**Planning Board – October 23, 2017, 6:30PM**  
**City Hall Council Chambers – 3 Washington Street, 2<sup>nd</sup> floor**

**AGENDA**

### SPR-11-17 SITE PLAN REVIEW – WATER & GROVE ST COMMERCIAL PARKING LOT

## SPR-12-17 SITE PLAN REVIEW – 183 Arch Street – Archway Farm’s Livestock Barn

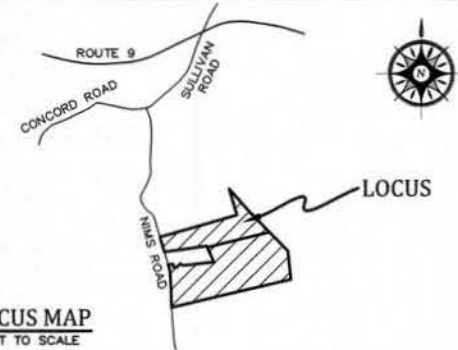
Code: *Add the label "Existing Dwelling" to the plan next to the building footprint on the lot at 74 Nims Rd.*

5. Flooding: The properties are not located within the 100-year floodplain. However, the U.S. Army Corp of Engineers (ACOE) may hold a flowage easement on the 5.64-acre of land that is to be conveyed from 74 Nims Rd to 86 Nims Rd. Staff have asked the Applicant to display this easement on the plan.

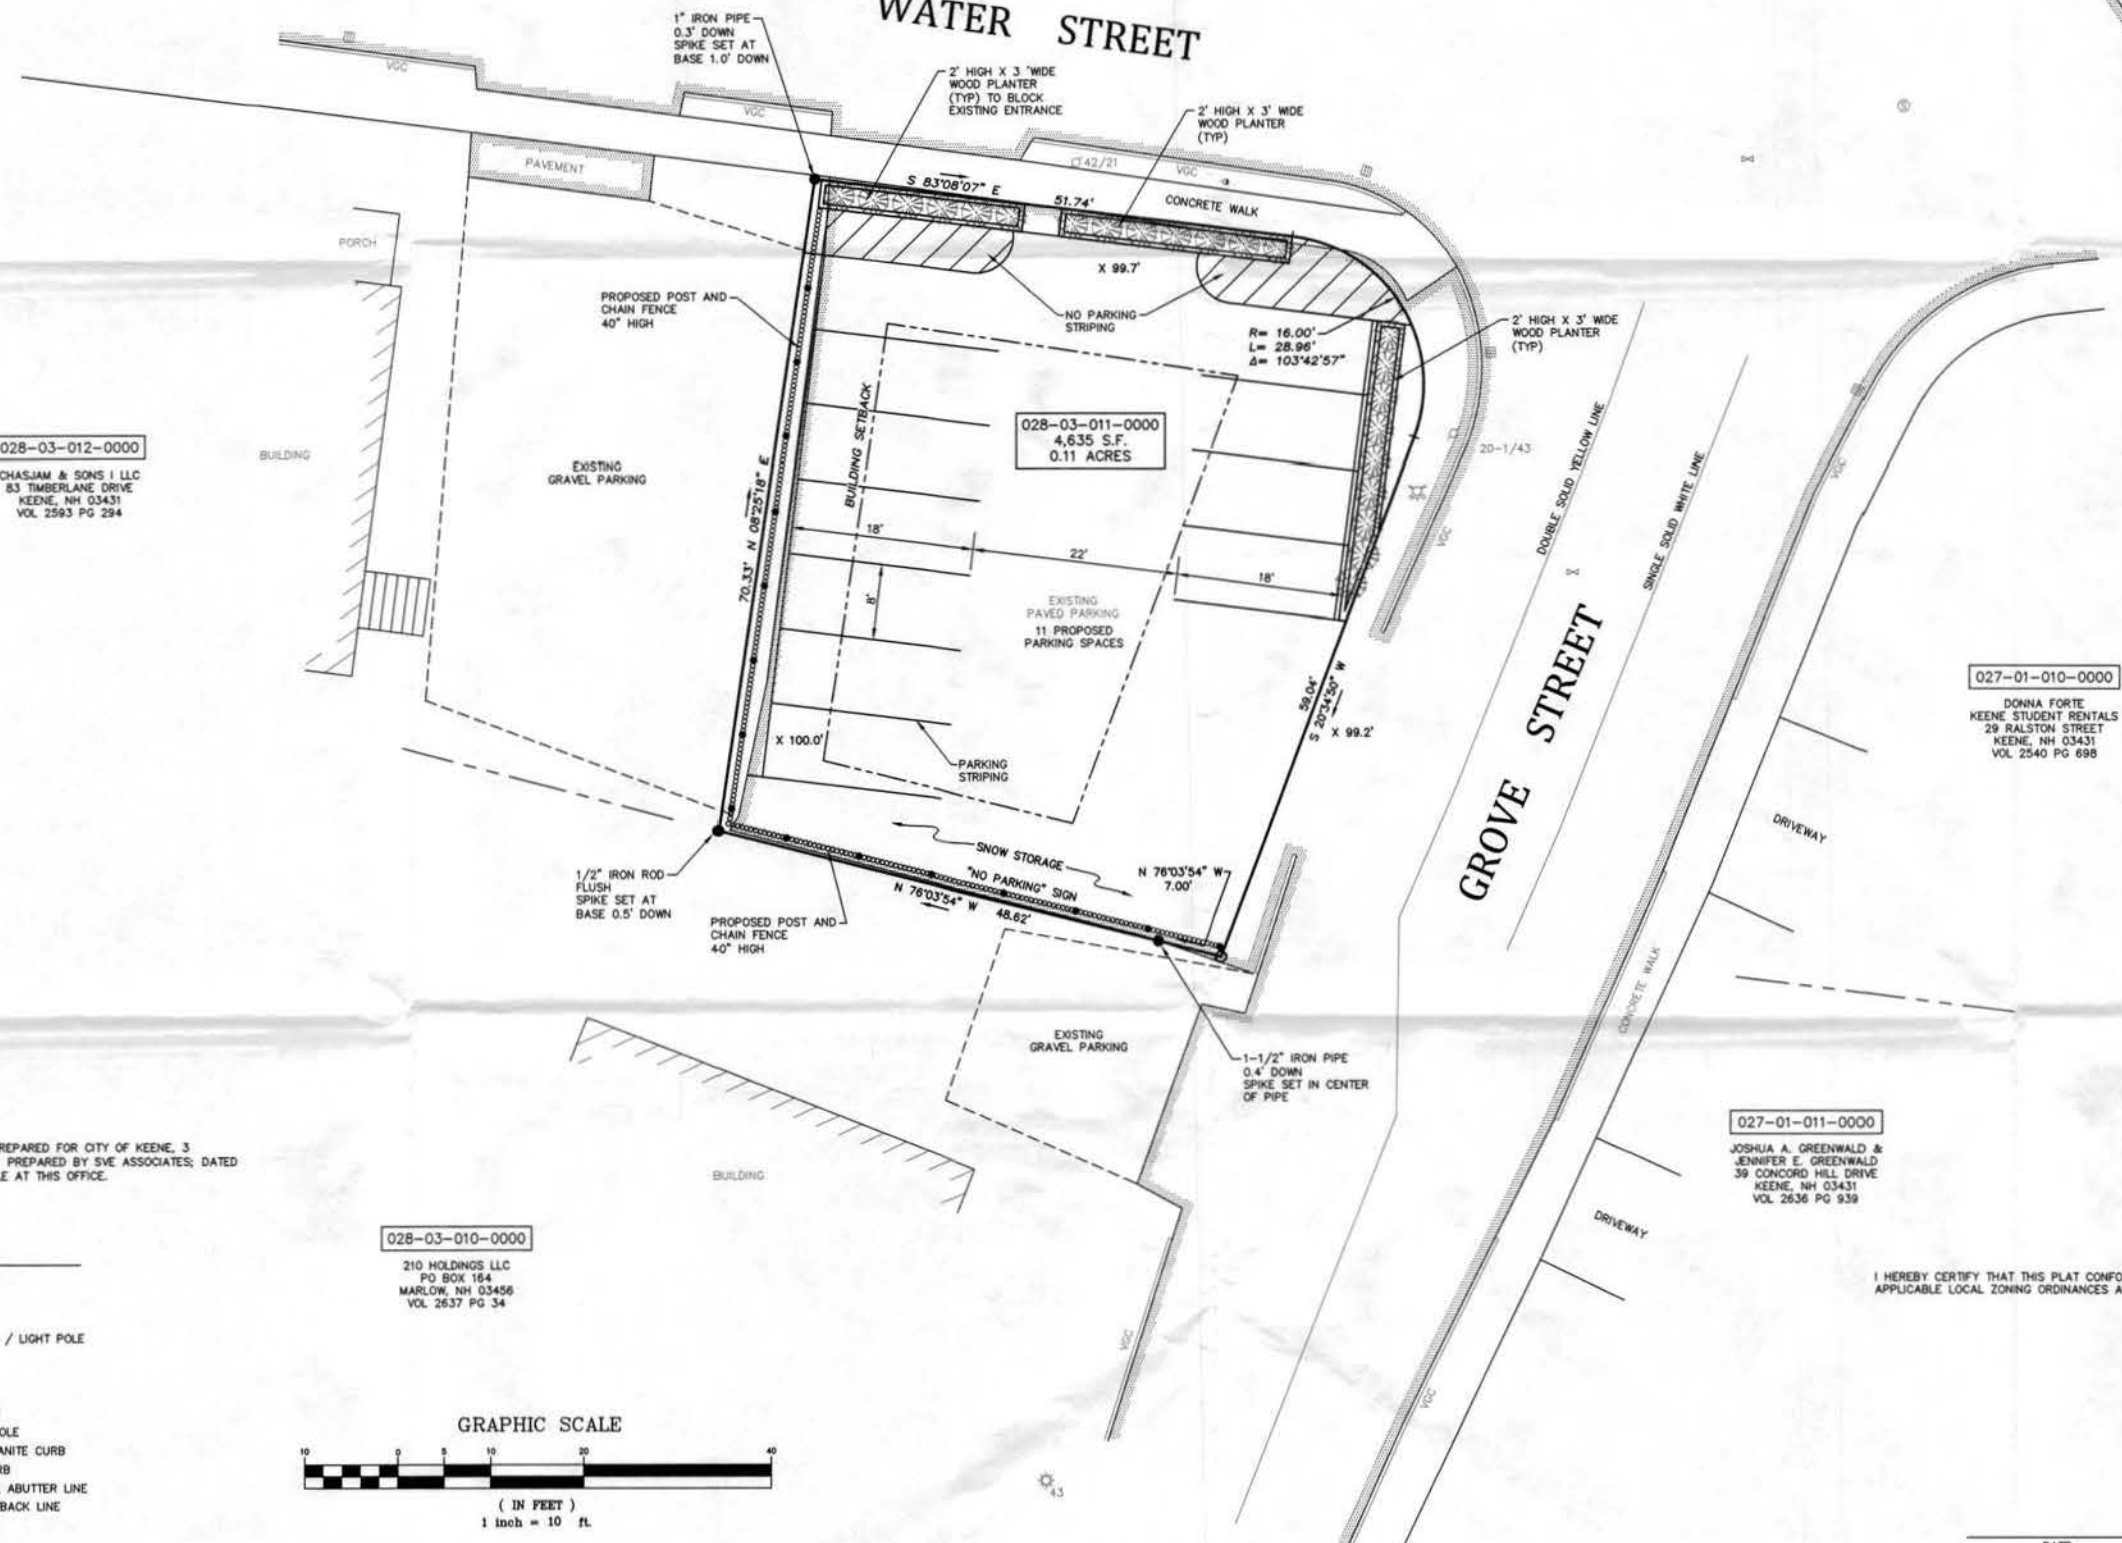
*"1. Please differentiate between existing and proposed conditions (For example, lot line, existing parking layout, etc.).  
2. Confirm that all lines and symbology used in the drawings is defined in the legend (For example, proposed fence, etc.).  
3. Provide plants schedule to make sure that the proposed planters will not impact visibility (line of sight) at the corner of Water Street and Grove Street."*

8. Screening: The Planning Board Development Standard for Screening (Standard #8) states that “landscaping should be used whenever possible...to screen vehicular headlights from adjacent properties.” The plan proposed by the Applicant does not include screening measures to address the headlights of the vehicles parked in the 7 parking spaces proposed along the western property boundary. The headlights of these vehicles would face the adjacent residential building on Water Street.

The Applicant is proposing to install a 32-foot long wooden planter that is 2-foot high in front of the 4 parking spaces proposed along the eastern boundary of the lot, facing Grove Street. The height of most vehicular headlights is between 2 feet and 4.5 feet off the ground. This planter with landscaping installed in it may provide some screening of headlights from adjacent properties and the roadway.

**Figure 1: PROPOSED STRUCTURE LOCATION**

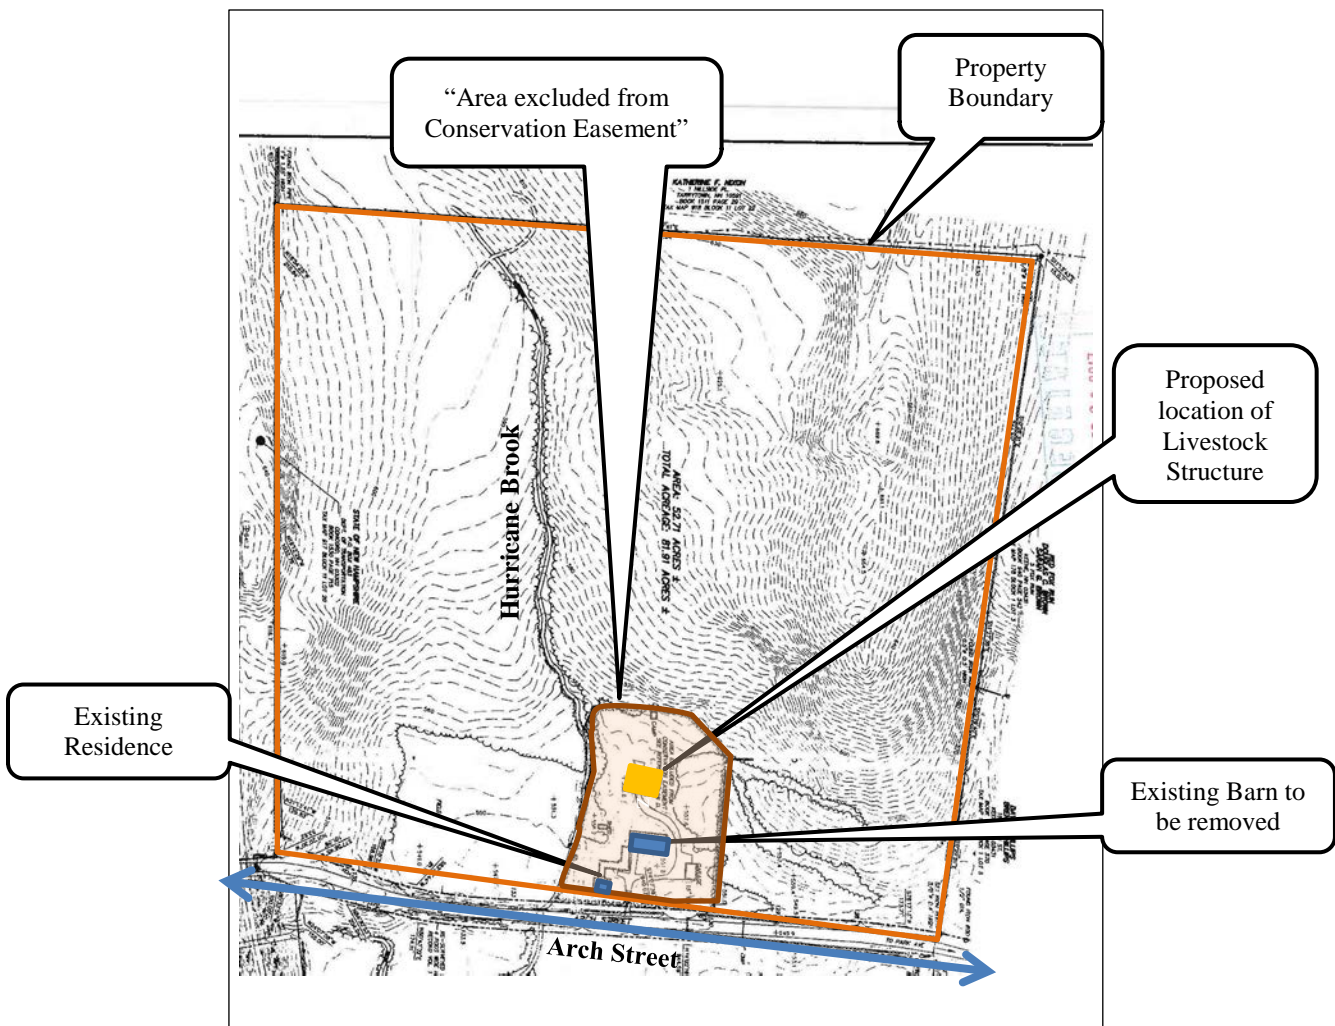
In the absence of this information, Figure 2 shows the location of the proposed structure in relationship to the City's surface water resource spatial data:
